## **1.0 Introduction**

By letter dated June 9, 2008, Westinghouse submitted Licensee Topical Report (LTR) WCAP-16943-P, "Enhanced Gray Rod Cluster Assembly (GRCA) Rodlet Design" (Reference 1) for review and approval. This Safety Evaluation Report (SER) is based on the submitted letter, and responses to requests for additional information (RAIs). Although the GRCA system is not a safety system, the staff reviewed the potential impact on safety systems following the appropriate portions of guidance provided in Chapters 4.2, "Fuel System Design"; 4.3, "Nuclear Design"; 4.4, "Thermal and Hydraulic Design"; and 15, "Accident Analysis", of the Standard Review Plan (SRP), NUREG-0800 (Reference 2) as applicable. The GRCA design as documented in WCAP-16943-P would be referenced as part of a future post-COL licensing amendment. WCAP-16943-P described an enhanced AP1000 GRCA intended to replace the Ag-In-Cd (AIC) GRCA absorber rodlet currently approved for use in the AP1000 Standard Plant. This SER does not cover any plant designs beyond the AP1000 Standard Plant.

Enclosure 1

**Figure 4.2-1** Thermal expansion of tungsten

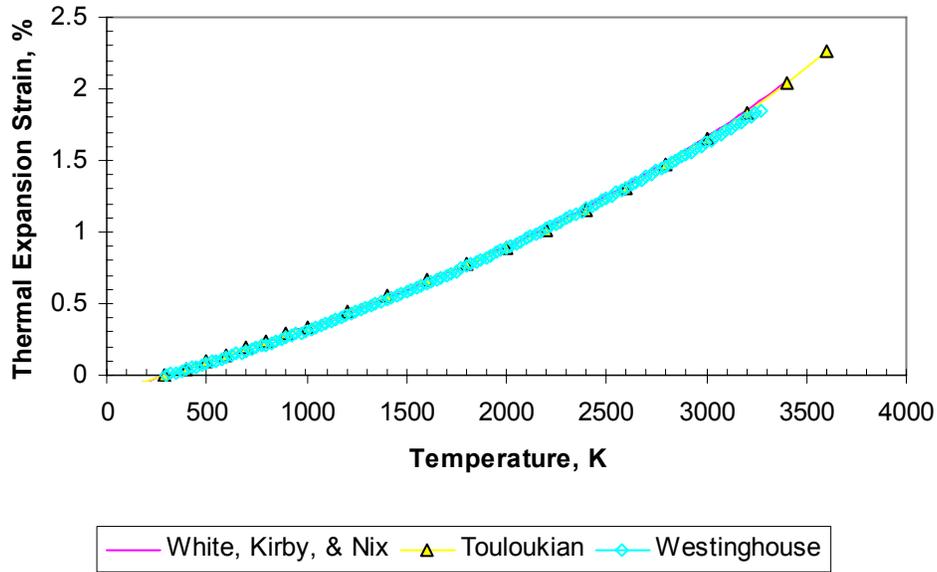
The applicant provided a correlation for thermal expansion of tungsten over the temperature range of 25°C to 2500°C. Figure 4.2-1 shows this correlation along with two other correlations previously collected by PNNL (References 5, 6, 7, and 8). The staff agrees that these correlations all show excellent agreement.

**Figure 4.2-2** Specific heat of tungsten

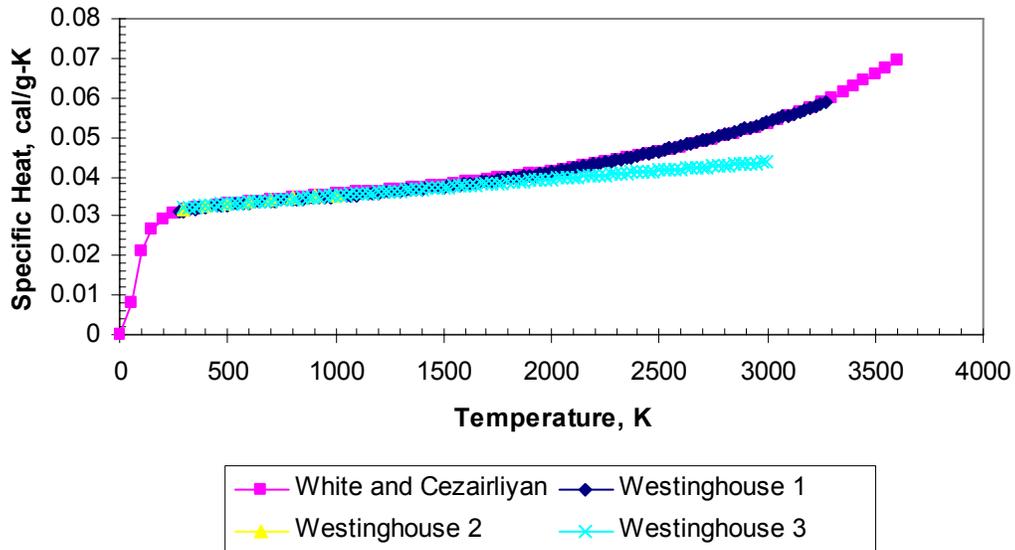
The applicant provided three correlations for specific heat of tungsten over the temperature ranges of 0°C to 3000°C, 25°C to 727°C, and 25°C to 2727°C. Figure 4.2-2 shows these correlations along with one other correlation previously collected by PNNL (References 9 and 10). The first and second correlations show excellent agreement with the PNNL correlation over the applicable temperature range.

The third correlation shows excellent agreement with the PNNL correlation up to a temperature of about 1230°C. Above this temperature the third correlation underpredicts the PNNL correlation and the first correlation.

Since the applicant gave three different correlations for specific heat of tungsten, the staff asked in RAI-02 (Reference 2) which of these correlations is used in the safety analyses. The applicant responded that there are no analyses that use the correlations for specific heat. This response is acceptable since it has no impact on any applicable safety analysis, but does provide additional general description of the material properties for tungsten found in open literature.

**Figure 4.2-3** Thermal conductivity of tungsten

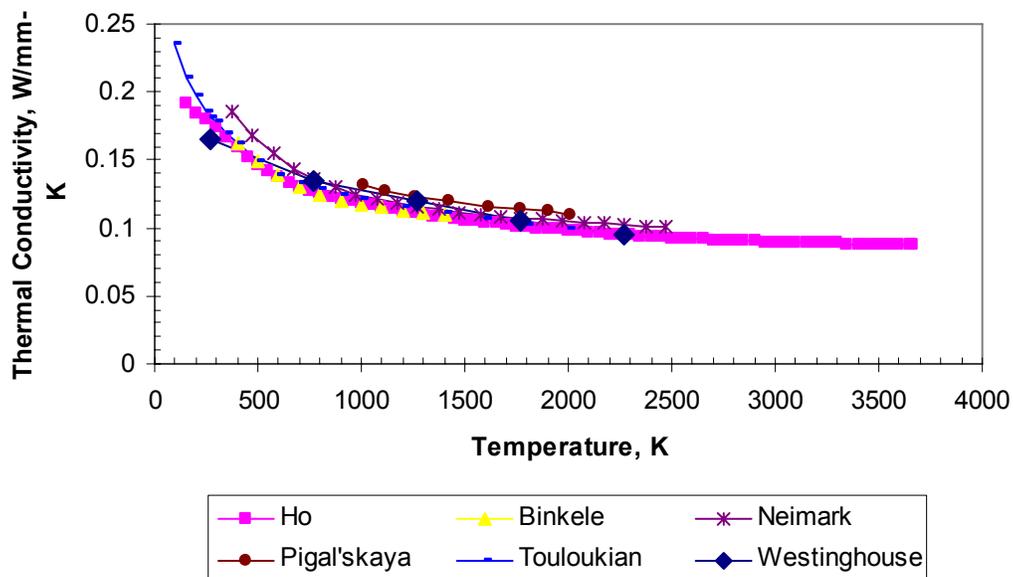
The applicant provided a data table for thermal conductivity of tungsten over the temperature range of 0°C to 2000°C. Figure 4.2-3 shows these data along with five other correlations previously collected by PNNL from the open literature (References 11, 12, 13, 14, and 15). The data provided by the applicant show excellent agreement with the open literature correlations within the uncertainty of the data.

**Figure 4.2-4** Young's modulus of tungsten

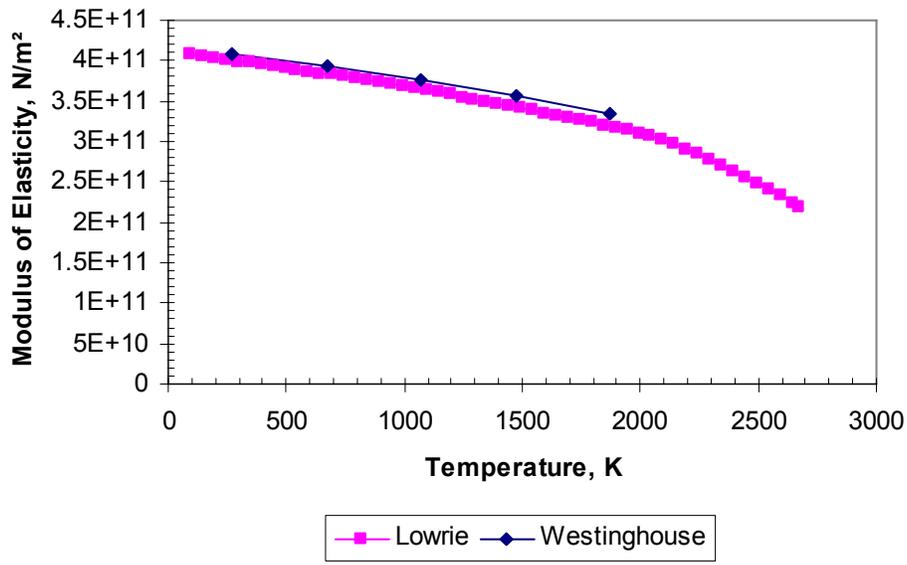
The applicant provided a data table for elastic modulus and Poisson's ratio of tungsten over the temperature range of 0°C to 1600°C. Figures 4.2-4 and 4.2-5 show these data along with a correlation previously collected from the open literature by PNNL for elastic modulus and Poisson's ratio, respectively (Reference 16). The data provided by the applicant show excellent agreement with the open literature correlations within the uncertainty of the data. The scale is expanded on Poisson's ratio in Figure 4.2-5, which suggests the difference is large, but the maximum difference is only 3%, which is considered to be within the uncertainty of Poisson's measurements; the difference is even smaller within the temperature range of this application.

Figure 4.2-6 Re/Os phase diagram

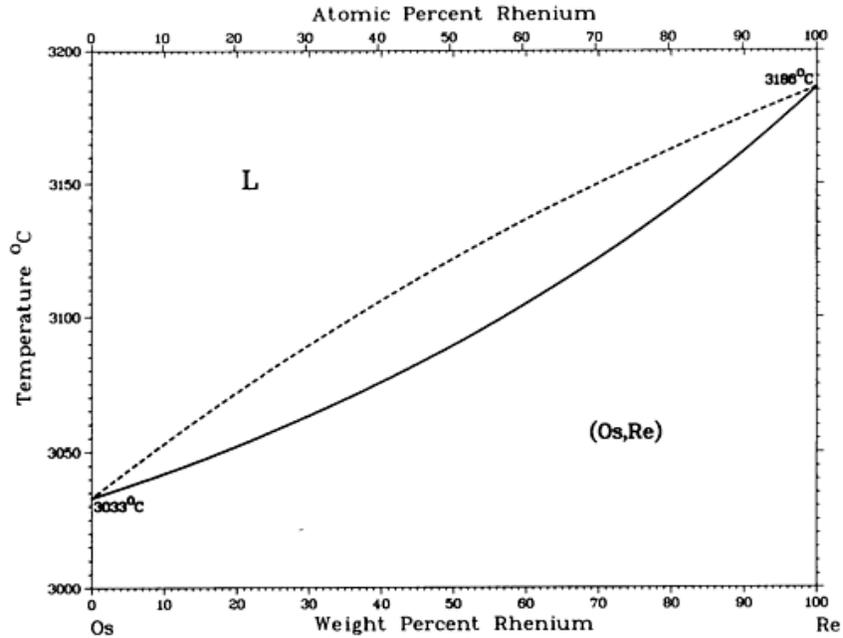
The staff noted that osmium (Os) is also formed throughout the service life of the GRCA rodlet. It is predicted that the maximum osmium content at end of life will be [ ]. Figure 4.2-6 shows the Re/Os phase diagram, which demonstrates that rhenium and osmium are mutually soluble in each other at all compositions (Reference 17). Figure 4.2-7 shows the W/Os phase diagram, which demonstrates that osmium is only soluble in tungsten up to 6 wt% (Reference 17). [ ] The staff asked

in RAI-05 for the applicant to discuss the impact of buildup of osmium on the material properties of irradiated tungsten. The applicant responded (Reference 2) by noting that the osmium content [ ]. The applicant also referenced a paper that stated that exceeding the osmium solubility limit is expected to cause a slight decrease in lattice parameter which would cause slight shrinkage of the material rather than swelling. This response demonstrates that the structural integrity of the sleeve is not compromised by the build-up of Os and is therefore found to be acceptable.

**Figure 4.2-8** Radiation swelling in tungsten and W-25Re

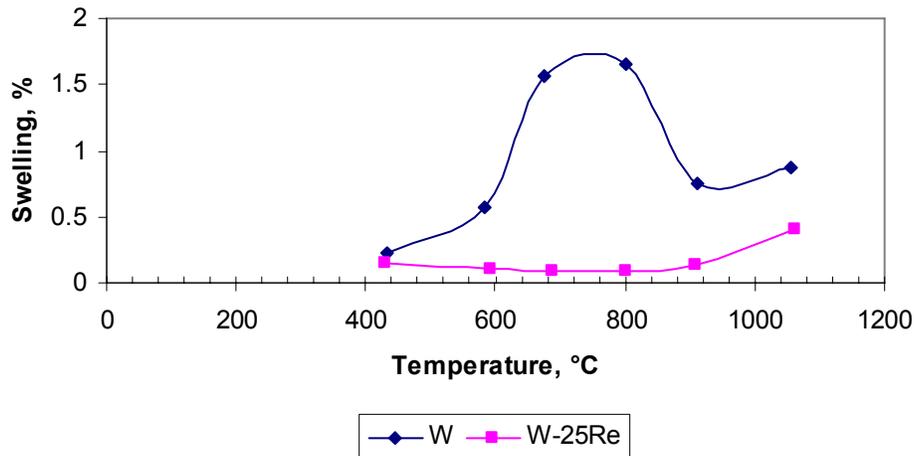
The applicant provided irradiation data for tungsten and W-25Re alloy to high fast fluences [ ] in the submittal. These data can be seen in Figure 4.2-8. These data demonstrate that the radiation swelling at [ ] will be a maximum of [ ], corresponding to a length change of [ ]. The staff noted that the lowest temperature at which the swelling data was taken was 430°C. The staff is aware of some materials such as SiC that have more severe swelling at lower temperatures than at high temperatures since vacancies and interstitials are not annealed out as rapidly at low temperatures. The staff asked in RAI-04 that the applicant provide an estimate of the tungsten absorber at normal operating conditions and, if this temperature is less than 430°C, that data be provided to justify the assumption of [ ] over the expected range of operating temperature. The applicant responded (Reference 2) that in evaluating the absorber swelling, [ ] would be used based on that measured in the tungsten at [ ]. This is conservative since the maximum tungsten temperature is expected to be [ ] swelling in pure tungsten of [ ], and swelling appears to decrease with rhenium additions due to transmutation. The applicant addressed the concern over low temperature swelling with an argument that swelling in refractory metals such as tungsten only occurs where the temperature is greater than 0.3 times the melting temperature. Based on the [ ] assumptions used by the applicant and inherent reduction in swelling with rhenium additions, the staff concluded that the applicant's response is acceptable.

Furthermore, the staff agrees that the swelling in tungsten is not expected to have a large contribution due to hydrogen and helium formation. Calculations have been performed by
